AERONAUTICAL CHARTING MEETING Instrument Procedures Group Meeting 21-02 – October 25-26, 2021

RECOMMENDATION DOCUMENT

FAA Control # 21-02-361

Subject: Differing TACAN Missed Approach Instructions

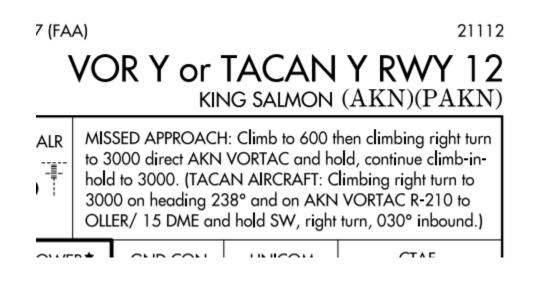
Quite often, these instructions (as they relate to TACAN aircraft) are unclear/ambiguous. In the above case, it's not immediately clear whether TACAN aircraft should brief the parenthetical as a *continuation of* or a *replacement to* the standard (VOR) missed approach procedure.

<u>Recommendations</u>: Garmin recommends a criteria change that provides additional clarity when there are two sets of missed approach instructions present on these types of procedures.

One avenue would be increasing the distinction between "continue" and an entirely separate, ground-up procedure. A second option could be splitting these into two charts, and only charting the portion of the missed approach that's relevant to the TACAN (notes, icon, charted path) on the new, second chart.
